**CALIFORNIA GEOLOGICAL SURVEY
FAULT EVALUATION REPORT FER 253
SUPPLEMENT NO. 1**

**THE HOLLYWOOD FAULT
in the Hollywood 7.5' Quadrangle
Los Angeles County, California**

by
Janis L. Hernandez
Engineering Geologist
November 5, 2014

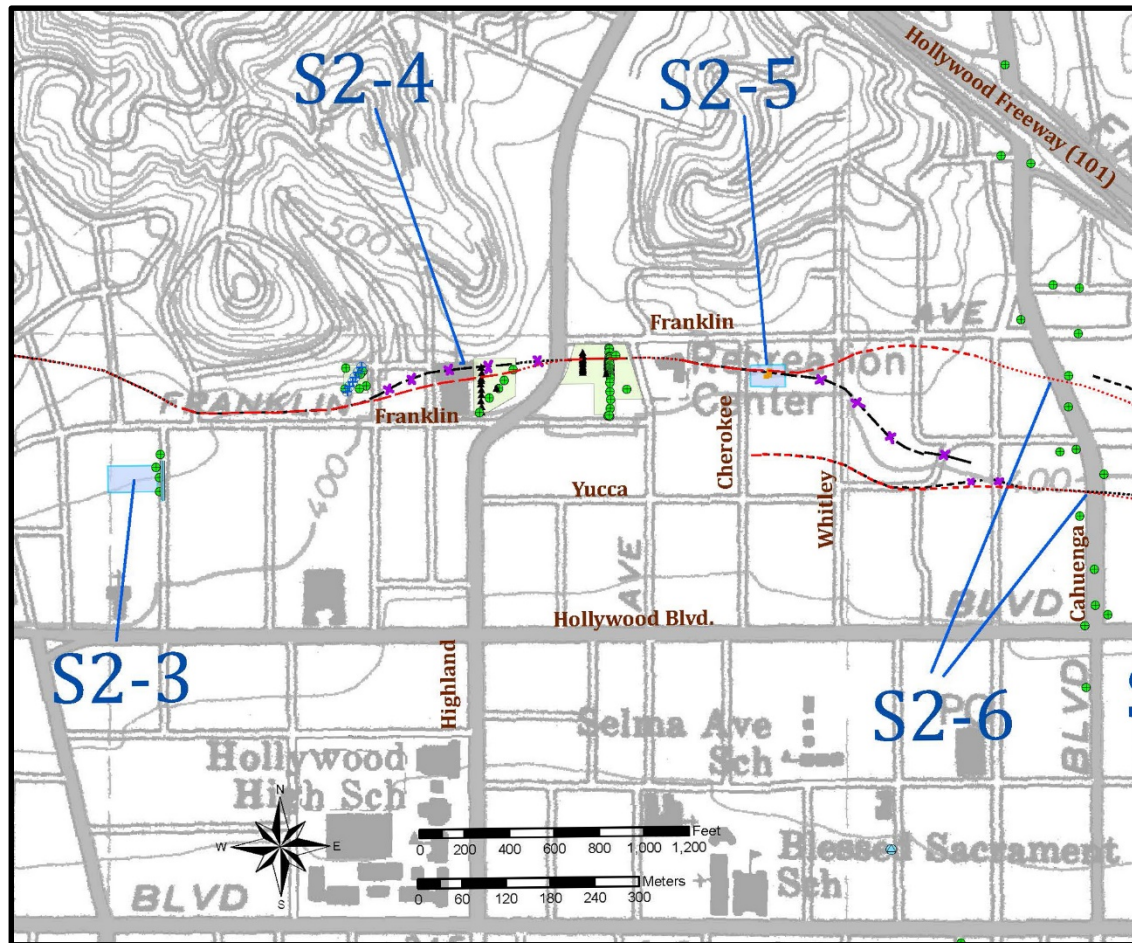
At locality S2-4 (Figure 5), (locality 12 in Hernandez and Treiman, 2014), CGS re-evaluated the fault strands at this site and compared them to the well-defined and well-constrained fault data immediately east of this location (Hernandez and Treiman, 2014), locality 13), as well as new data to the east at locality S2-5 (described below). There were several fault strands indicated in investigations at this site, and the re-assessment of the data led us to select a different strand as the dominant trace.

CGS made observations of two fault trenches at locality S2-5, south of Franklin Avenue and N. Cherokee Avenue (Figure 5). Two separate visits were made to this site by J. Treiman (CGS). The southern trench, first visited on December 31, 2013, exposed southeast dipping Topanga Formation siltstone and sandstone, with interbedded or injected volcanics. No faults were observed in this trench at this time. A northern trench, visited on January 15, 2014, revealed a broad fault zone (about 20 to 30-feet wide) within the Topanga Formation. Bedrock to the north and south of the fault zone dipped moderately to the northeast. Within the fault zone, bedding and shears had an east-west strike with steeply north to vertical dips. Shearing increased toward the northern margin of the zone which had a sharp vertical shear and a soil-filled fissure. The north margin of this soil-filled fissure appeared planar, indicating the soil was faulted, rather than just falling into a shaking-related fracture. A visit to a freshly cleaned exposure at the initial southern trench, also on January 15, showed a shallowly north-dipping shear within the bedrock to the graded surface. Soils overlying the bedrock in the northern trench appeared to be very young. To date no report has been submitted by the owner to the City of Los Angeles or CGS.

Based on our re-evaluation of these data, we suggest a modification of the fault trace slightly to the south to project through this preferred trace, connecting the well-located fault to the east with better defined scarps to the west.

Our observations confirm the location of the northern strand of the Hollywood fault as presented in the initial FER.

Figure 6 – Cross section from the Metro Red Line subway project. Portion of figure from Converse et al, 1984.

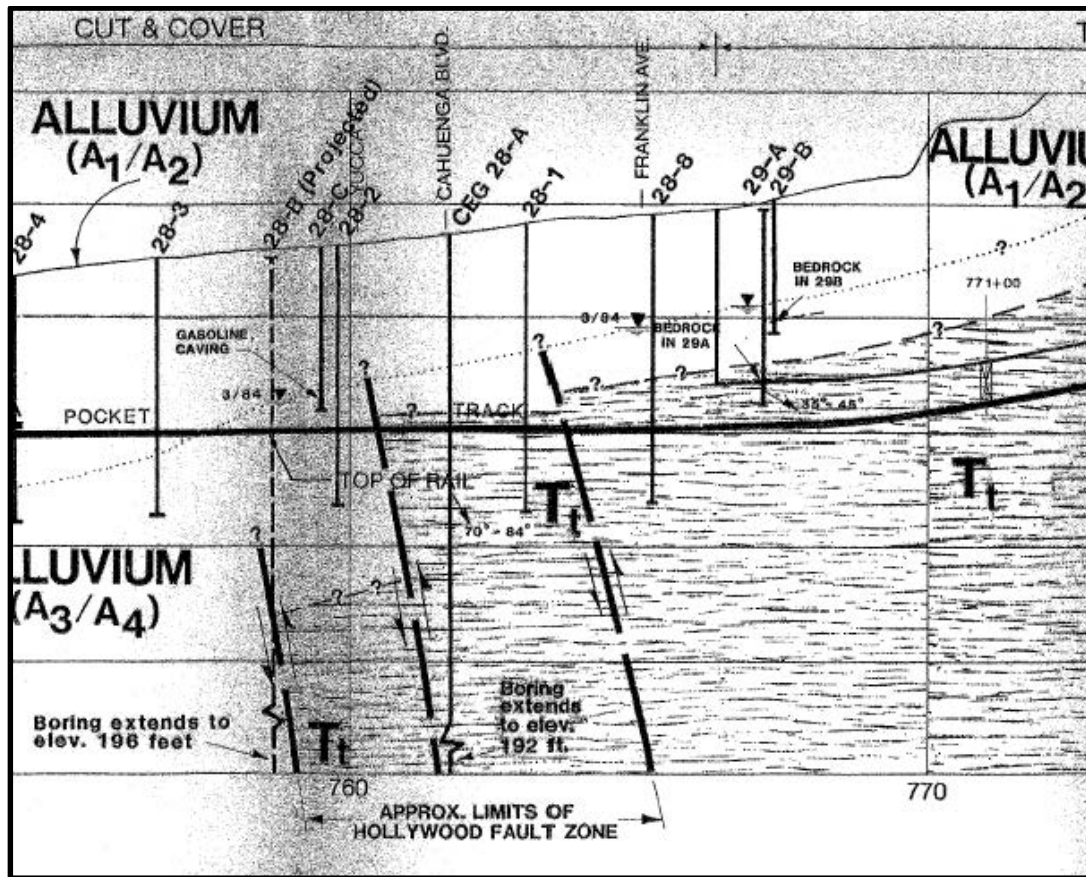
The data presented by Converse Consultants et al (1984), specifically a cross section (Figure 6 herein) and boring logs, combined with observations of the fault at locality S2-5, support an eastward continuation of the northern fault trace, rather than the southeast trending orientation shown in the initial FER (that was based on Dolan et al., 1997)(Figure 7). We find the stratigraphy within the MTA boreholes reveals lateral discontinuities within the upper alluvial soils above the principal fault strands, in addition to offset bedrock as illustrated in the cross-section (Figure 6). The Converse Consultants data also supports the location of the southern trace of the fault where it crosses Cahuenga Boulevard as shown on the preliminary Alquist-Priolo Earthquake Fault Zone map. Additionally, the cross section shows a third fault that projects toward

the ground surface at Yucca Street, roughly between the northern and southern strands (Figure 6). Due to uncertainty as to how the various strands of this complex fault zone connect to the east and west we are only depicting the northern and southern fault traces on the Official Zone map.

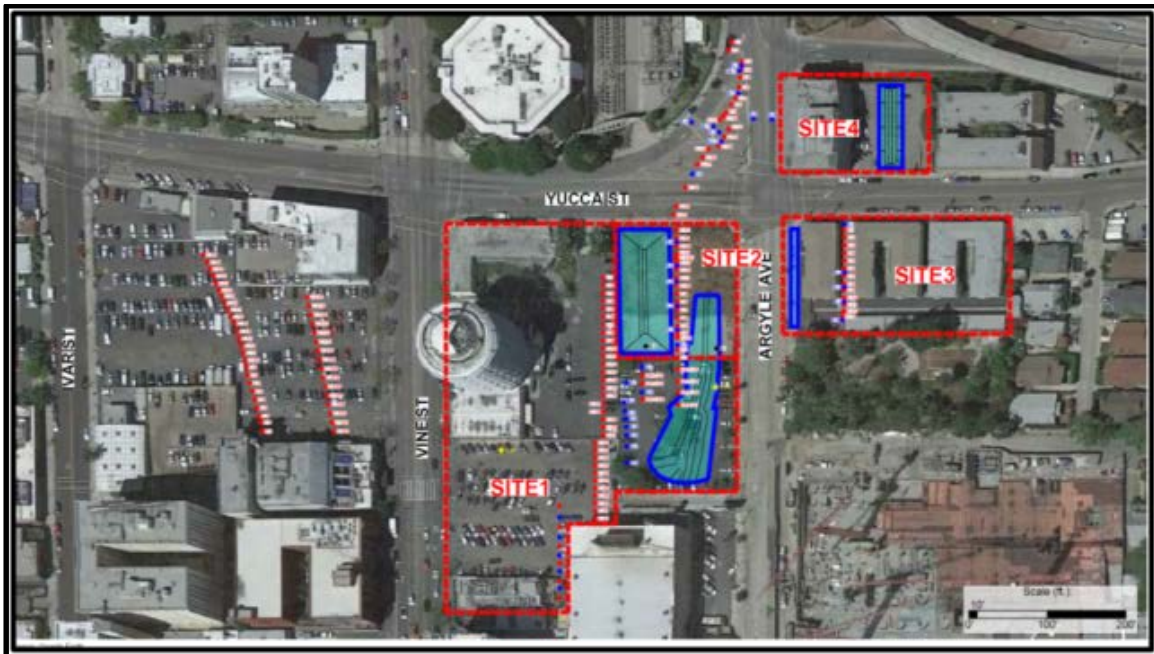
A fault study, conducted by Group Delta Consultants, Inc. (2014a) was submitted to the SMGB on May 6, 2014 for locality S2-8 (GDC Site 2, Figure 8). This study included core boring and CPT transects and an approximate 100-foot long, 30 foot deep trench on the western portion of the site. GDC reported that they found no evidence for faulting in the Holocene units on this site. The study also reported age estimates of weathered soil horizons at two locations within the trench, prepared by Dr. Roy Shlemon, and included test results from two charcoal samples submitted for C14 dating.

GDC reported the site is underlain by fluvial channel deposits, locally named the Argyle Channel, which they estimate to be Holocene. Underlying the Argyle Channel deposits, they report a clayey sand layer. The contact between the lower clayey sand and the overlying Argyle Channel sands is reported to be an erosional unconformity. The lower clayey sand is reported to be at least 12 to 15 ka, based on relative soil pedogenic development exposed in the trench. Age estimates by GDC are based on soil development described by Dr. Roy Shlemon, in Appendix B of their report, and correlation of the unconformity with ice age sea-level low stand at during marine isotope stage 2. Radiocarbon dates reported for the Argyle Channel deposits were about ~4.3 ka, and ~41 ka at about 14 feet, and 18 feet below the ground surface (bgs), respectively. GDC prefers the soil-stratigraphic and paleo-environmental age estimates for the Argyle Channel deposits and does not use the radiocarbon dates.

A second Fault Activity Report was submitted by GDC for locality S2-8, dated September 3, 2014 (Group Delta, 2014b). This investigation consisted of additional CPT and core borings from adjacent sites in the vicinity, and an additional trench located on the eastern portion of the site that also extended south into GDC Site 1 (locality S2-9). During this second investigation, GDC reported a bedding plane fault underlies the site, where they concluded this fault is overlain by a buried paleosol “indicative of about 30 ka of weathering.” This trench was excavated in response to comments by the City of Los Angeles noting that faulted Pleistocene sediments were found directly across the street to the east (GDC, Site 3; locality S2-11). Within this eastern trench at locality S2-8, Argyle Channel deposits were exposed, underlain by mudflow deposits (previously referred to by GDC as the clayey sand or “basal clay” unit). Underlying the mudflow deposits they reported well-consolidated older alluvial debris flow deposits that are dipping gently to steeply to the south. C14 dates near the base of the Argyle Channel deposits were reported at ~4.1 to 4.3 ka. (Group Delta, 2014a, 2014b). The soil ages within the trench were derived from soil profile descriptions from R. Shlemon. GDC concluded that folding and related slip observed in their trench occurred prior to deposition of the mudflows, capped by a remnant buried paleosol of about 30 ka, and are overlain by the unbroken, estimated ~12 ka Argyle Channel deposits.

The data presented in the GDC report appear to be consistent with the interpretation that the Argyle Channel deposits are of Holocene age. However, multiple C14 samples GDC reported within their trenches near the base of the Argyle Channel, are only ~4.3 ka and thus the channel deposits do not represent the complete Holocene record. We consider the Argyle Channel deposits to be approximately 6 ka, based on C14 data throughout the two trenches, and related soil development. The interpretation that the underlying clayey deposit is pre-Holocene appears to be consistent with the reported data. Detailed analysis of the soil profile development was prepared by G. Seitz, of CGS, and is included in Appendix A of this supplement. This analysis includes further comments regarding the reported age classification of the Argyle Channel deposits, and underlying clayey sand unit.

The data presented in the GDC report regarding faulting of these deposits is also open to alternate interpretations. The trench log and correlation by GDC show that Argyle Channel deposits are unfaulted across much of the site. CGS performed a field review of the west trench on two occasions, the first was not extensive enough to verify all of the consultant's conclusions due to safety concerns, however a subsequent visit afforded the opportunity to view the clayey sand deposits and relative soil development at the base of the trench. Our review of the CPT and core boring data for GDC Site 2 finds the Argyle Channel sand unit appears to be continuously correlated between borings and CPT tests, however the underlying clayey sand unit is shown to be discontinuous across portions of the site. Our review further notes the cross sections illustrated by GDC favor the CPT correlations, where core boring data in some areas does not directly support their stratigraphic interpretation.

Based on this new trench data, as well as other data, we have relocated the northern fault strand to project along Yucca Street toward the north. The southern fault strand is also modified in this area based on data from locality S2-9 (GDC Site 1), described below.

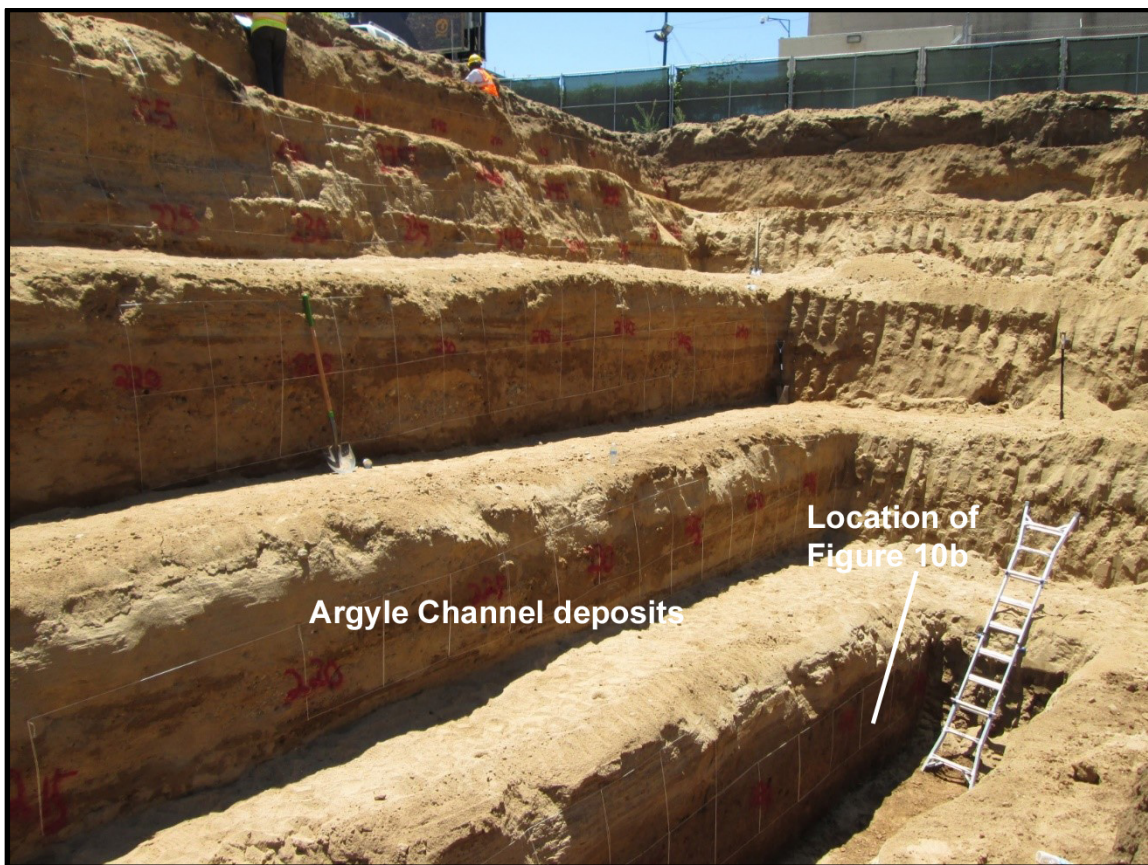
CGS was invited to the site for periodic trench review between June 30, 2014 and July 11, 2014, where we observed unbroken Argyle Channel deposits overlying an older unbroken unit that was tentatively correlated by GDC staff to mudflow deposits observed to the north. In the northern portion of Site 1 near the boundary with Site 2, the late-Pleistocene mudflow unit appears to be draped over the underlying folded debris flow units, and what may be the same unit appears near-horizontal as it extends to the southern end of the trench (Figure 10a).

We received no logs of this part of the trench to clarify these relationships.

Figures 10a, 10b show the stratigraphy in the south end of the trench. Our review of the CPT data for this site, and some earlier core borings (from GDC Site2) indicates a discontinuous south-dipping Quaternary stratigraphic section, with a prominent stratigraphic break toward the southern end of the property indicative of a fault. The orientation of this break appears to be north-dipping, projects upward toward the ground surface near the southern property boundary (south of the trench exposure), is in alignment with the fault scarp located north of Carlos Avenue immediately to the east, and is in alignment with an inferred fault trace from the Langan data west of Vine Street (locality S2-7) to the west. On the basis of these observations, the southern trace of the Hollywood Fault has been moved to the southern boundary of locality S2-9, just south of the trench exposure.

Figure 11 – Cross-section from GDC Site 3 showing anticlinal folding of Pleistocene debris flow deposits, inferred stratigraphic form lines and faults that offset this unit. Numbered annotation at each fault reflects GDC’s observed stratigraphic separation at each location. Figure from GDC, 2014c.

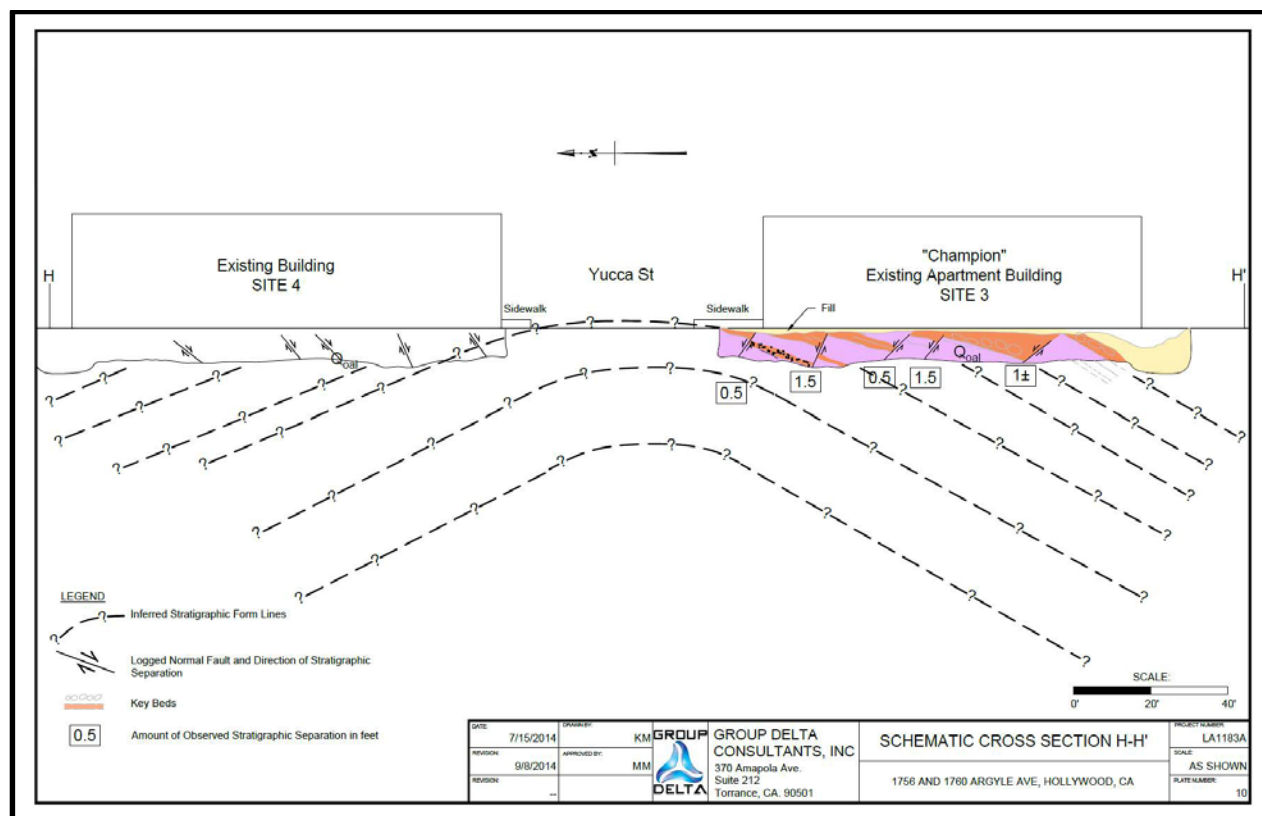
The data presented in the GDC report is consistent with the interpretation that the deposits are of Pleistocene age although it is unclear why these “debris flow” deposits are differentiated from the similarly comprised and deformed older alluvial fan unit exposed and described at site 2.

Interpretation that the faults are local bending moment faults is not consistent with CGS field observations within the trench. CGS noted a significant lack of correlation across the southernmost fault, and that thickness of units changed across most of the faults, which indicates a component of lateral displacement (Figure 12). The southernmost fault appeared to be a prominent fault, as correlative units across the fault were not found, suggesting this fault trace may have seen the most displacement. No evidence for, or against, Holocene faulting was reported on this site because Holocene deposits, if present, were likely removed during site development.

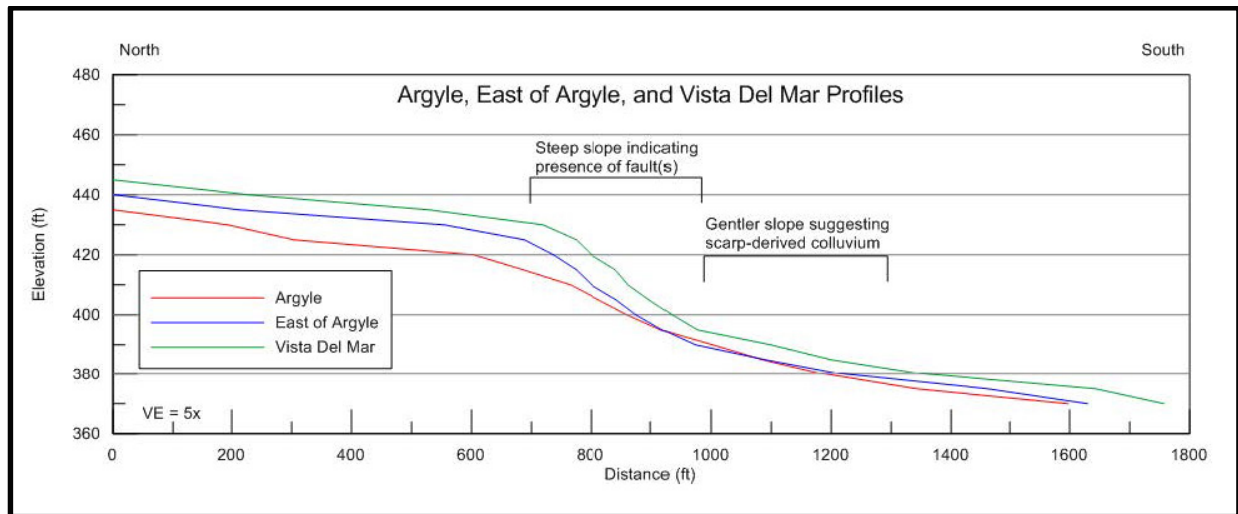
LCI stated that in addition to the prominent break in slope located immediately north of their site, a subtle break in slope is expressed across the southern portion of the site. They reported this southern slope break is located south of the southern discontinuous fault trace mapped by CGS. They suggest that subtle breaks in slope can be related to several factors: change in slope direction on the ground surface, or thickness and directional changes within the alluvial fan system. Their analysis noted that the subtle slope break is coincident with an east-west trending apparent scarp mapped by Hill et al. (1979), and a possible fault scarp mapped by Weber et al. (1980). In their review of the 1926 topographic maps, they indicated that Argyle Avenue did not yet exist at this location, and that possibly the subtle break in slope observed in the street may have been created during subsequent construction of Argyle. Alternatively, they concluded that this subtle break in slope reflected in the composite topographic profiles (Figure 13), is most likely related to scarp-derived colluvium from the steep break in slope to the north.

The data presented in the LCI report was particularly helpful in CGS review of topographic breaks in slope. Fault traces mapped by CGS in this area were based on geomorphic interpretation using similar data as used by LCI, as well as fault traces from Dolan et al. (1997), Hill et al. (1979), and Weber et al. (1980). In addition, the southern discontinuous fault trace was mapped using original subsurface data from Geotechnologies, Inc. (2006) that included logs of borings and the site topographic base map. CGS review of the high resolution street survey data submitted by LCI in their report, and detailed observations included in the Geotechnologies (2013) report, finds justification to modify our interpretation of the location of the principal southern fault trace.

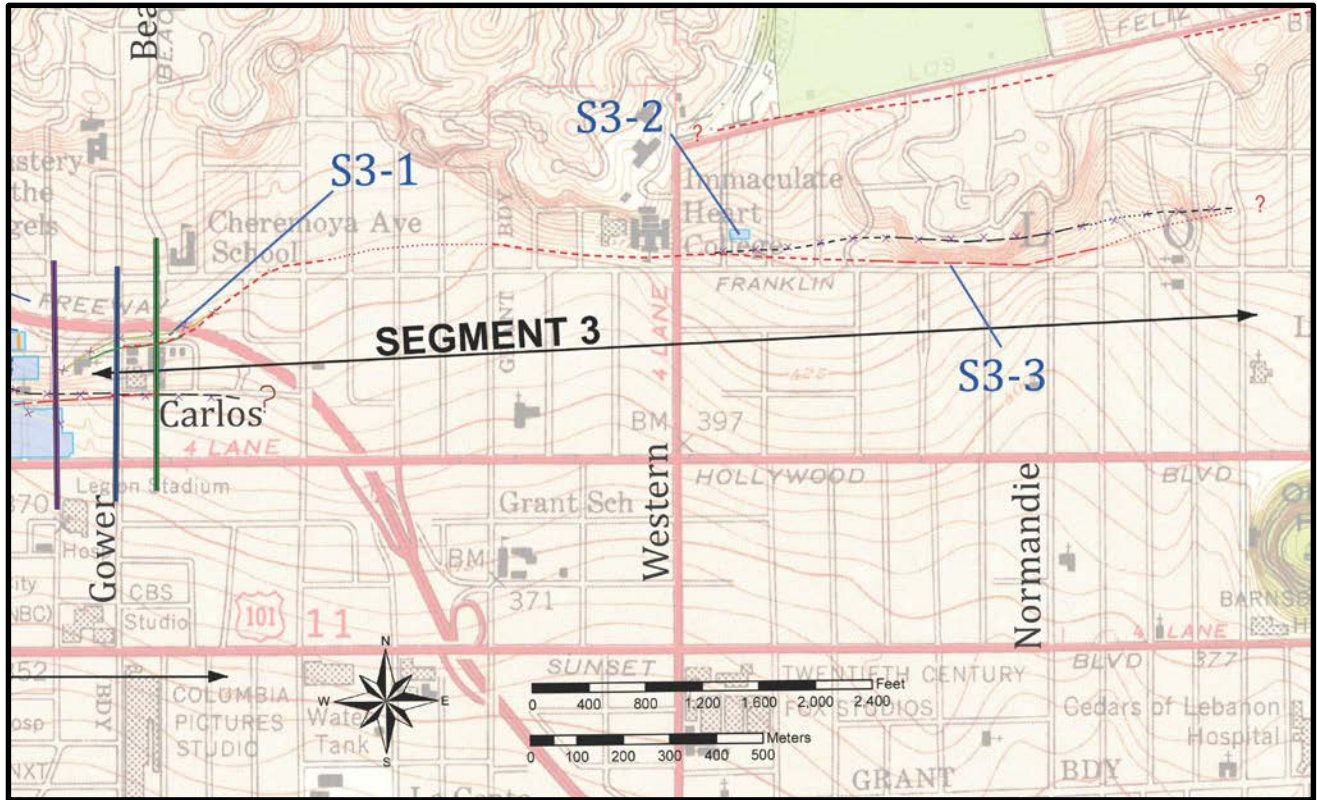
At locality S3-3 (Figure 14), CGS revised the location of the Hollywood Fault trace along Franklin Avenue east of Western, based on a review of the 1926 topographic map covering this area. Our initial interpretation in this area utilized a later version of the topographic map, where topographic details were more subtle. Our reinterpretation of the fault trace follows closely with the trace mapped by Dolan et al, 1997.

As a result of this minor adjustment, the EFZ boundary has shifted slightly to the south.

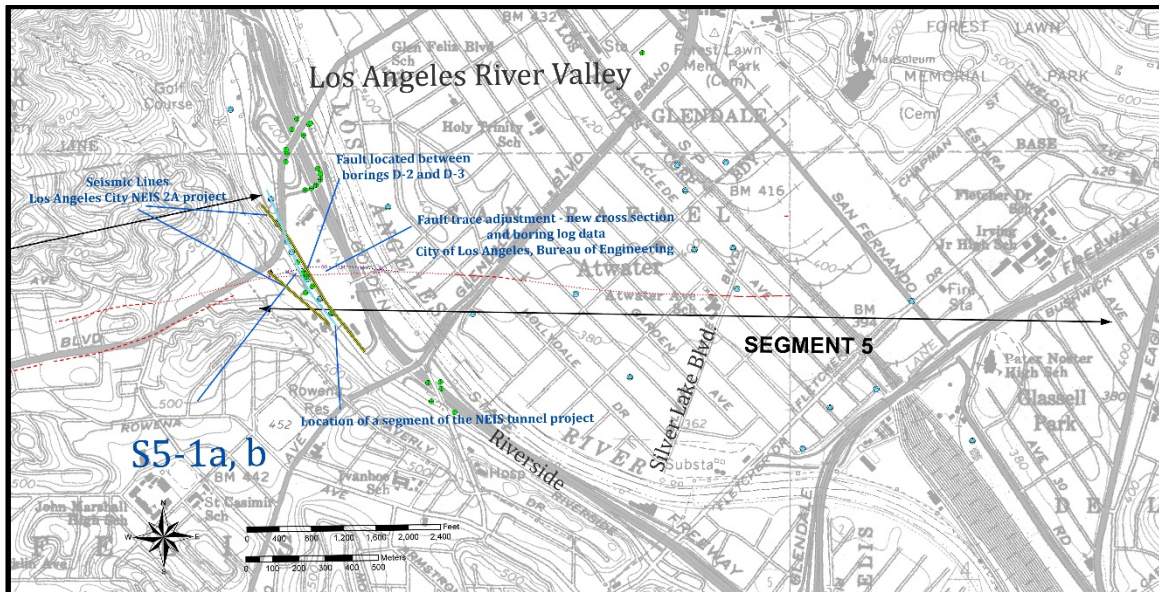
Our review of the updated cross section and boring logs received from the City of Los Angeles (locality S5-1b), finds that the original projected surface trace of the fault should be shifted to the south approximately 90 feet. We have revised the location of the fault trace based on this new cross section and supporting data. A corresponding revision of the zone boundary has been made.
